PCS TRANSMIT UPDATE

- **Draft text changes laubach_3bn_03_0315.pdf**
- **Hole filling for upstream CNU PCS and CLT/CNU harmonization**
 - Data Detector Updates
 - Same data detector input process for CLT and CNU
 - Brought back certain elements from Figure 76-16
 - 2 Idle count, End of data, transmitting status
 - Slightly updated CLT output process
 - New CNU output process
 - Added accumulation of a burst time header 65-bit block that is extracted at the CLT based on notion from Figure 76-14
 - Added two pseudo-code functions that define upstream codeword filling, end of burst detection, and interaction with PMA client
 - Added all used constants, variables, and functions
 - Updated transferToPMA process to be usable by both CLT and CNU
 - Found some Clause 76 typos, will submit comment
 - Fixed some “65” vs “66” issues
 - Removed now redundant text and unneeded subclauses

(a) OLT state diagram

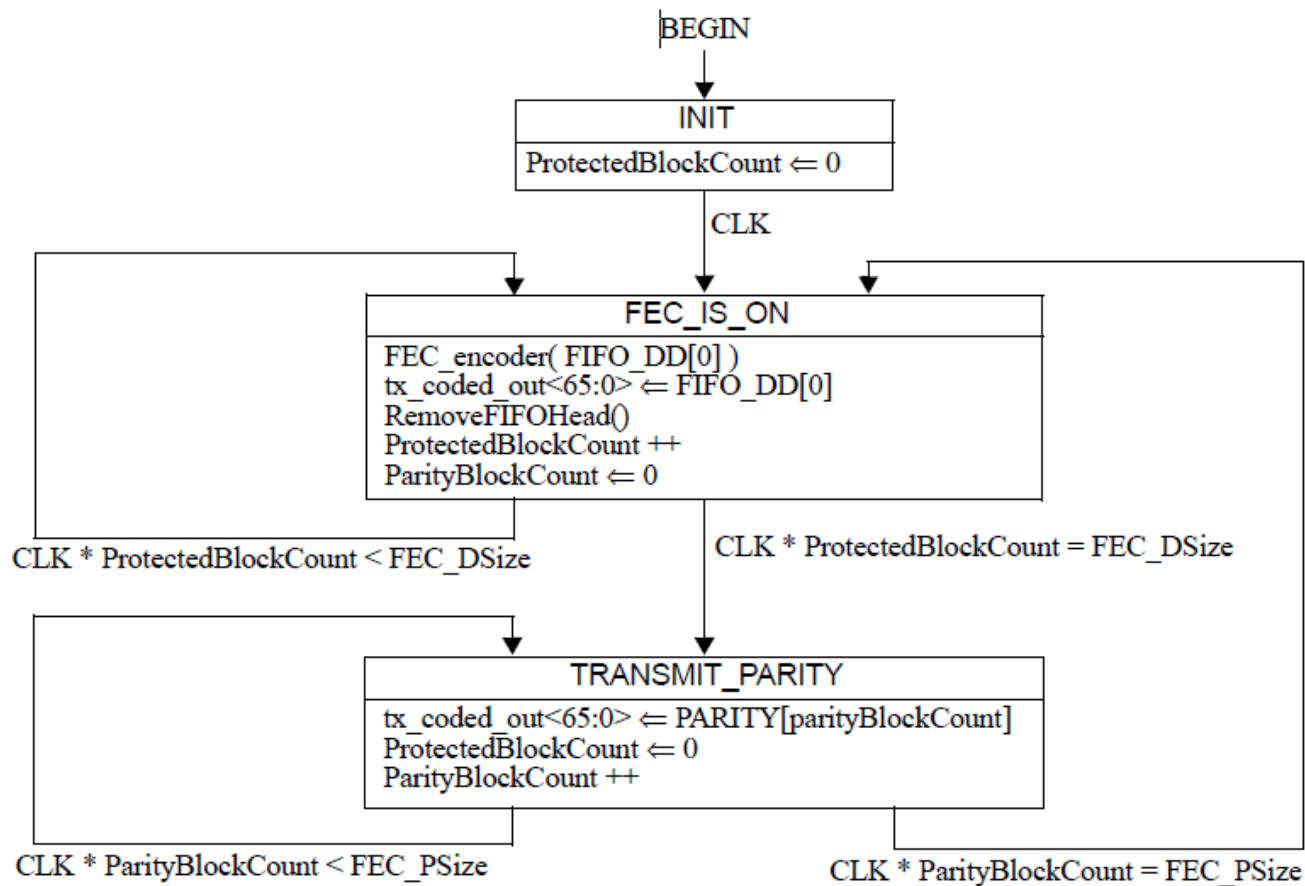
CLAUSE 76 REVIEW – OLT D.D. OUTPUT

(b) ONU state diagram

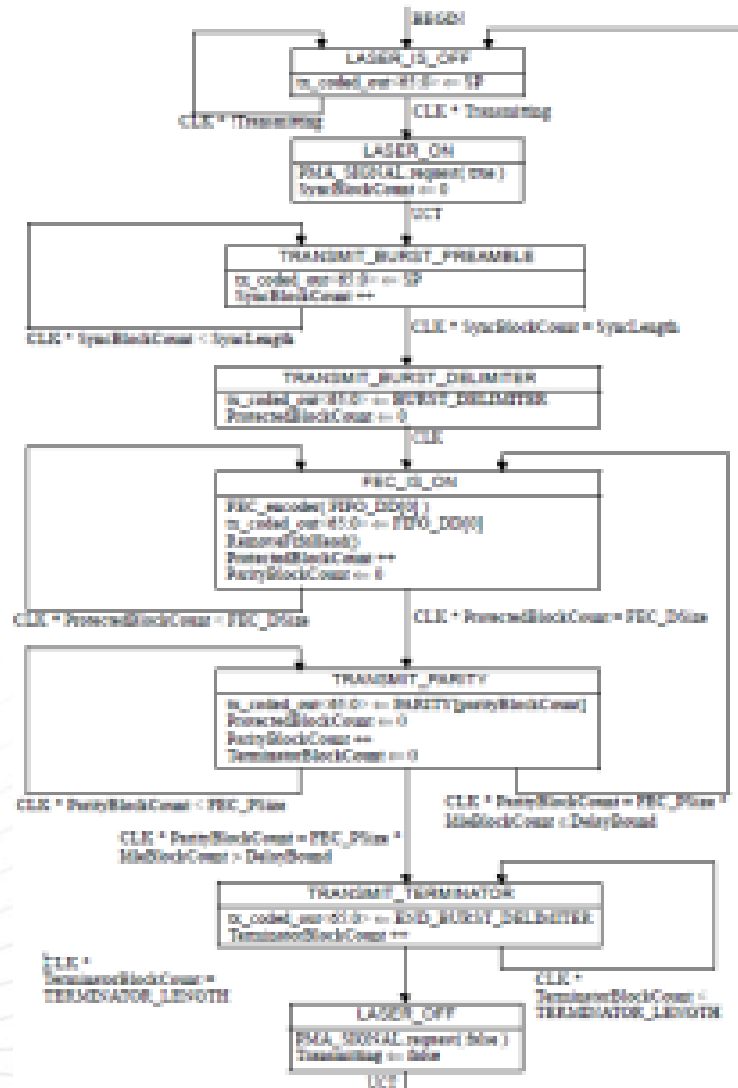
CLAUSE 76 REVIEW – ONU D.D. OUTPUT

Yes, figure is large, see PDF page at end of this presentation.
